Shinest Apparels Ltd

Azim Tower, Plot No. 217/1, Beribadh, Mohammadpur, Dhaka, Bangladesh
(23.768754N, 90.345978E)
24 May 2014

Observations

As-built column grid

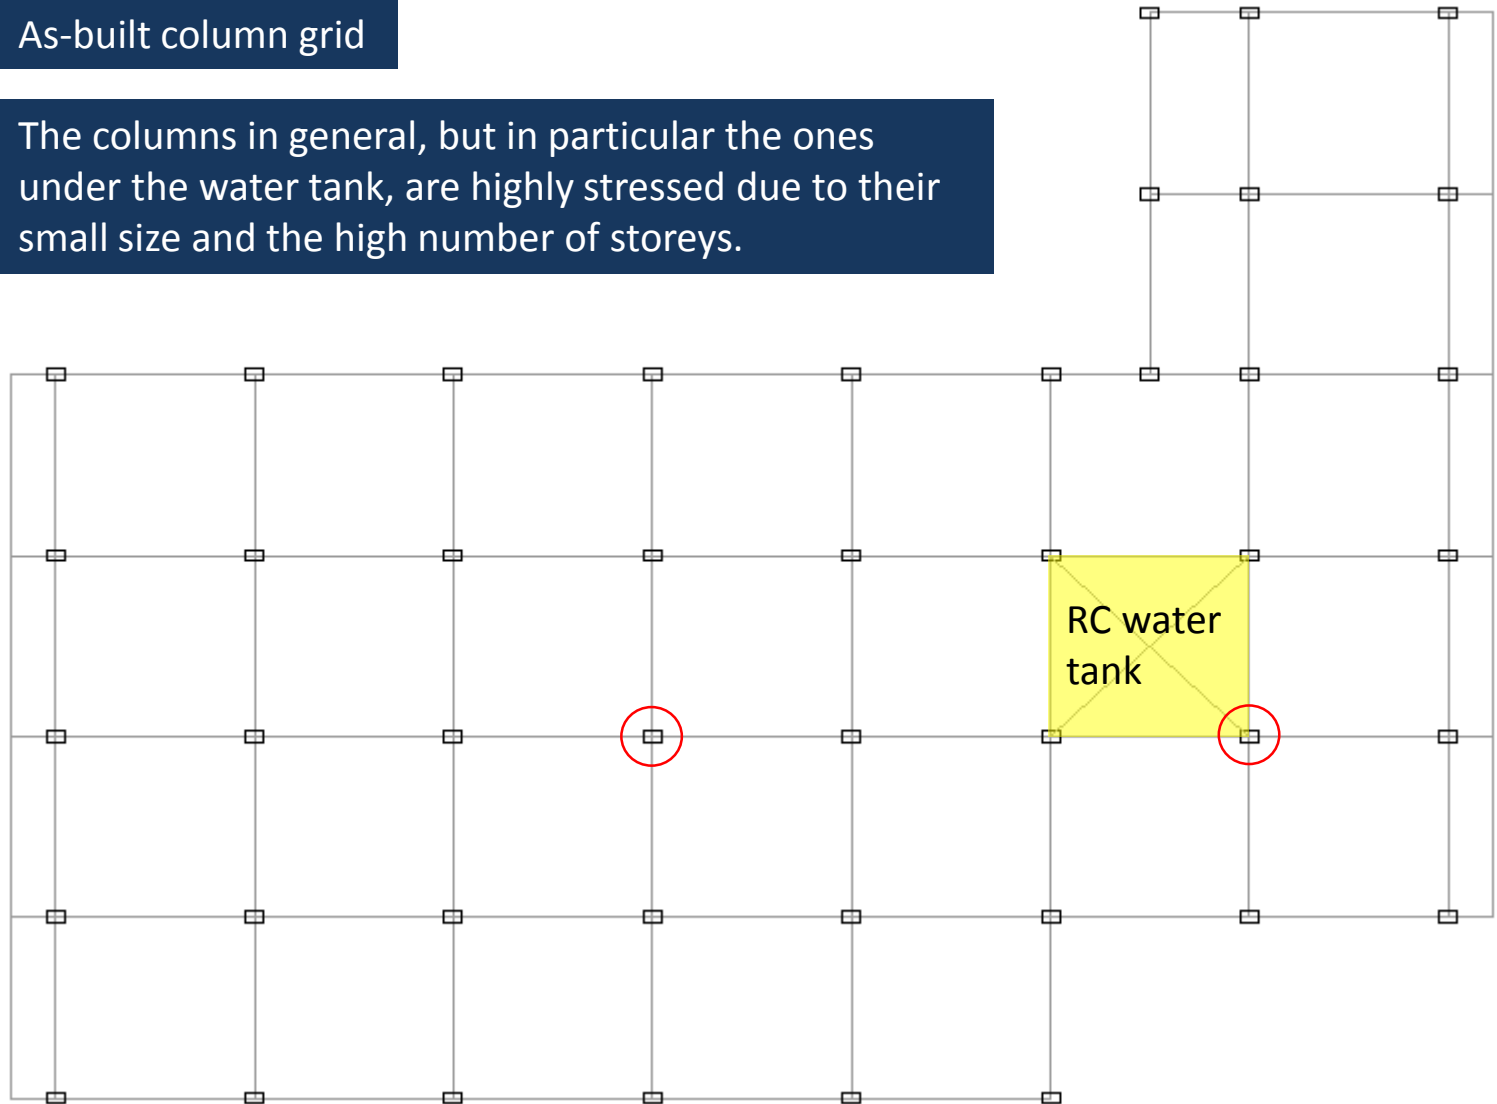
Small column sizes leading to high column stresses

The columns in general, but in particular the ones under the water tank, are highly stressed due to their small size and the high number of storeys.

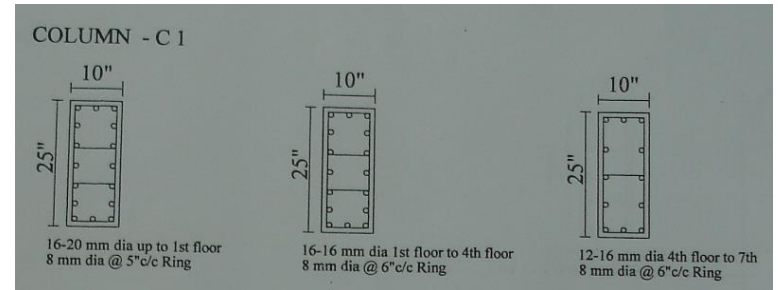
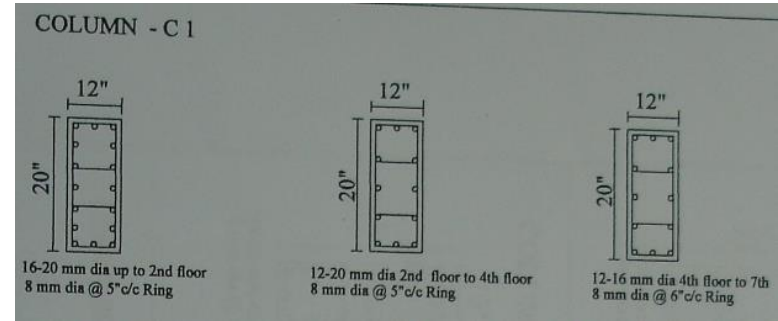
High punching shear stresses in some areas of the flat slabs

The reinforcement drawings are inconsistent regarding slab thickness and reinforcement quantities.

The punching shear stress is high for some columns, e.g. 1st internal combined with small column size based on a slab thickness of 7".
With a slab thickness of only 5", the punching shear stresses would be high for all columns.

The column sizes vary in the different storeys (e.g. 495 x 300mm on 7th floor, 650 x 320mm on 1st floor).

Scanned column reinforcement

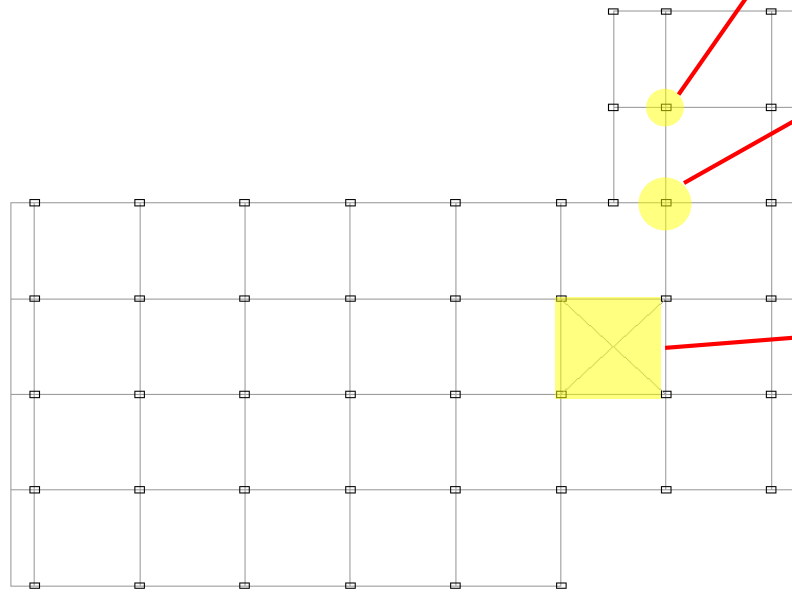
Discrepancies between observed and documented column reinforcement

There are discrepancies in the reinforcement drawings for the columns regarding size and reinforcement amount.

A typical column should have 3 bars on its short side and 7 bars on the long side. Several columns were checked and the number of bars on the long side seem to deviate from the drawings.

Permit drawing

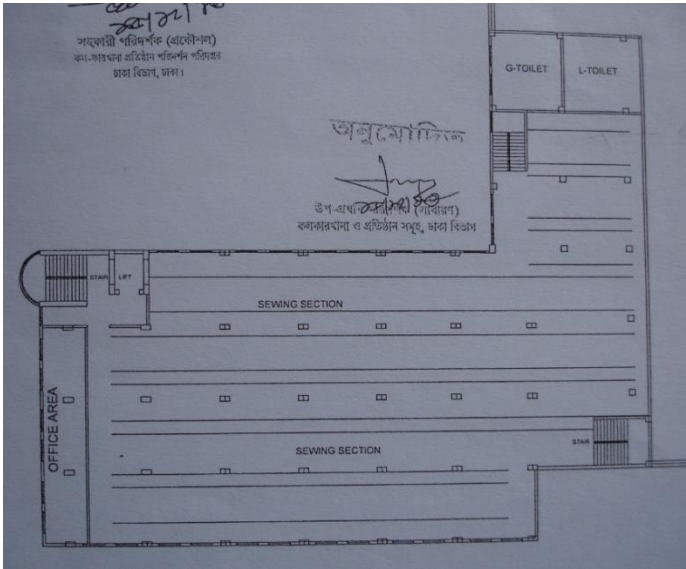
Inconsistencies in documentation / building permit

The permit drawings are inconsistent with the structural drawings.

As-built layout

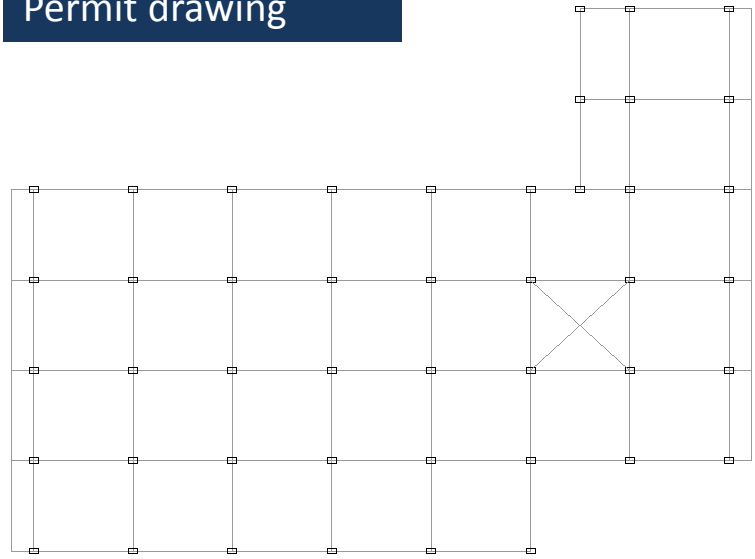
The as-built structure deviates from both in some areas.
